Alaska Railroad Corporation
327 W. Ship Creek Ave.
Anchorage, AK 99501

Addendum 2
ITB #22-53-311675
Curry Ballast Production

Addendum number 2 has been issued for questions and closing date change.

TITLE : QUARRY DEVELOPMENT SITE PLAN

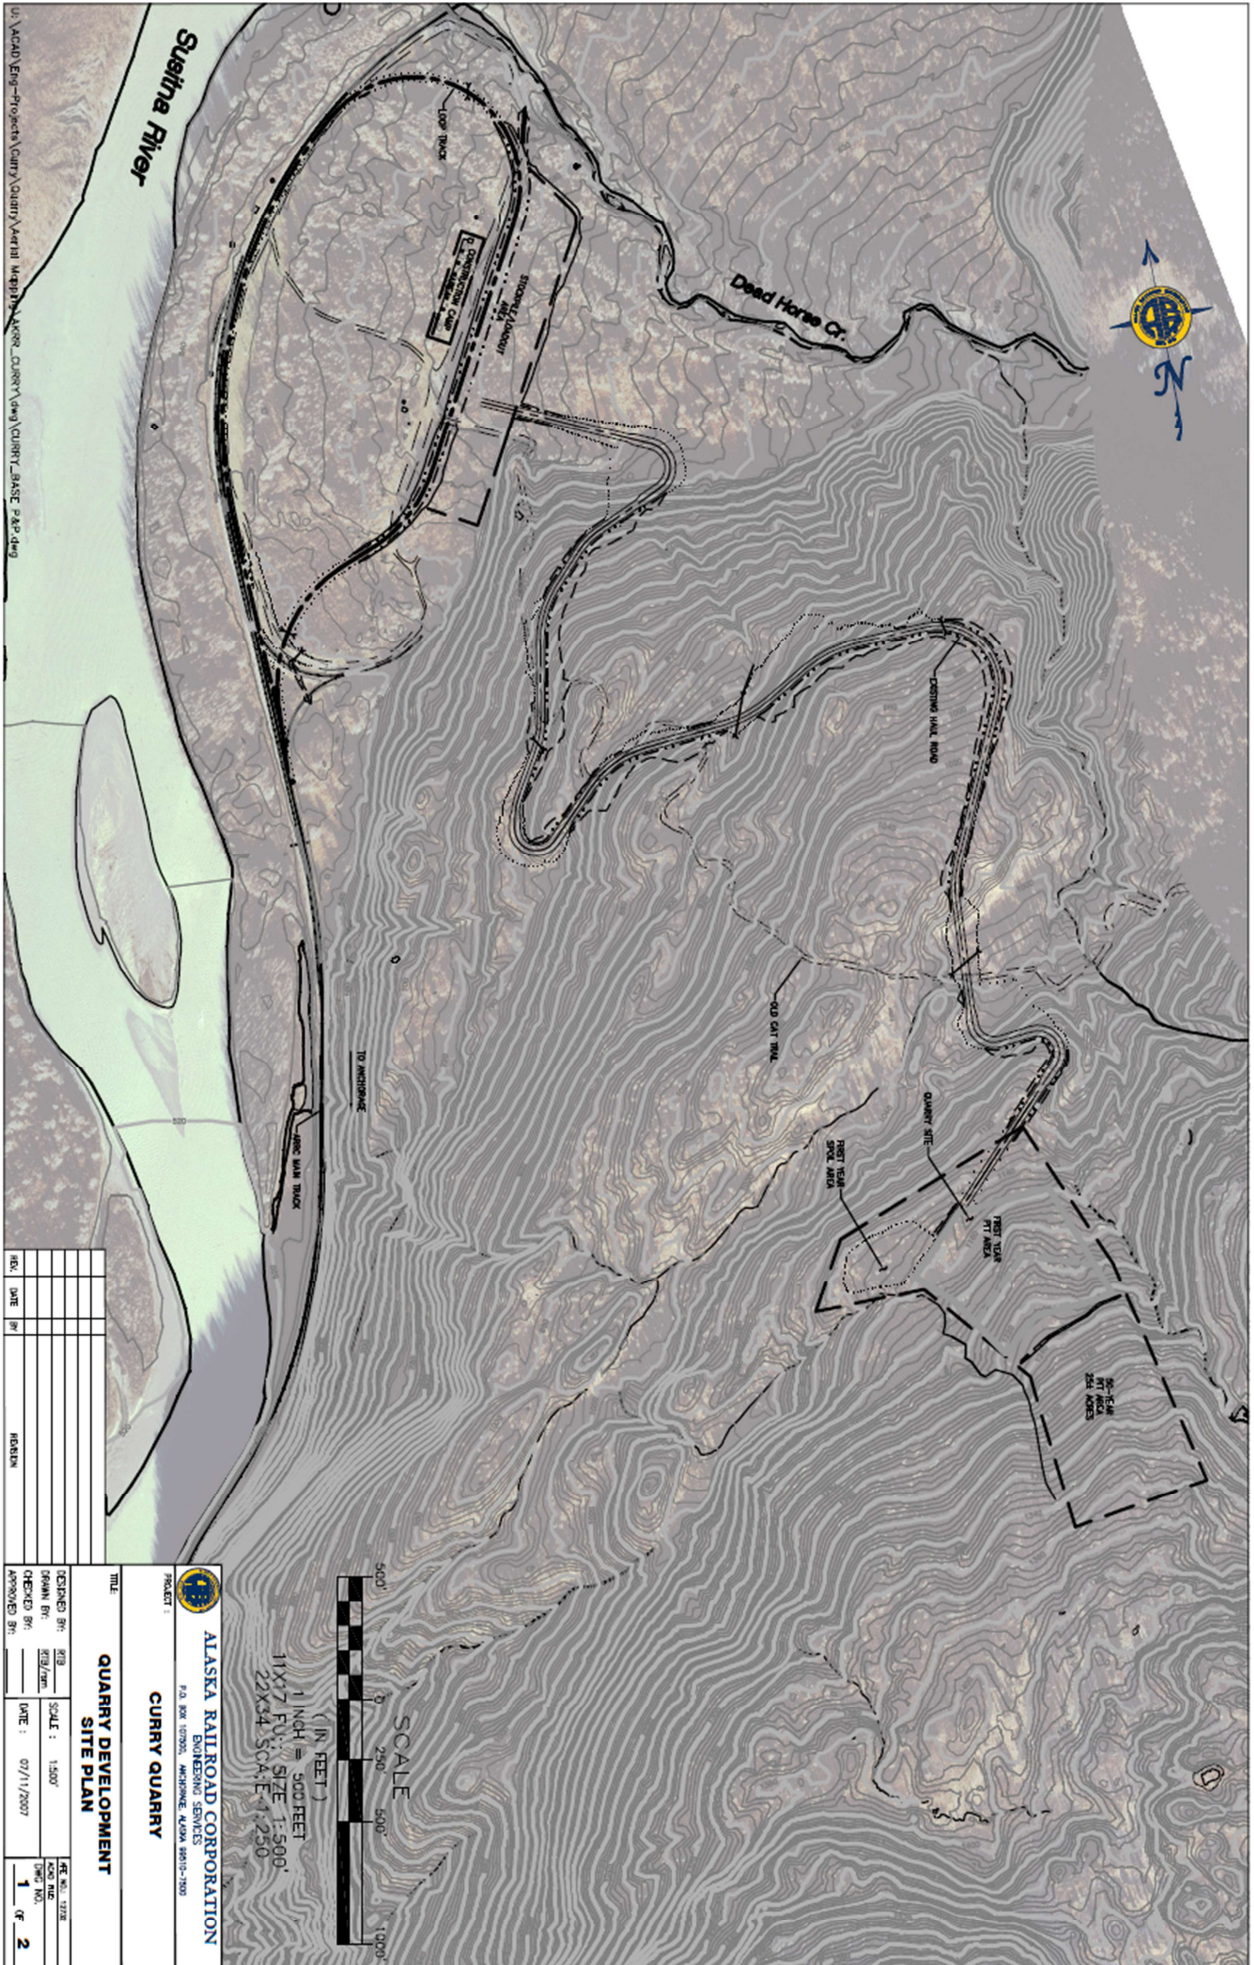
1. Would it be possible to clear additional land, create settling ponds, and develop additional wells at the lower stockpile yard so that the final washing can occur closer to water source?

Answer: Yes Pending permitting. Depending on the specific location, SHPO consultation may be required.
2. If this is aggregable, would it be possible to stockpile ballast in final location with a conveyor to keep the material as clean as possible? This would require weighing material prior to washing or utilizing belt scales, would these be suitable methods of measurement?
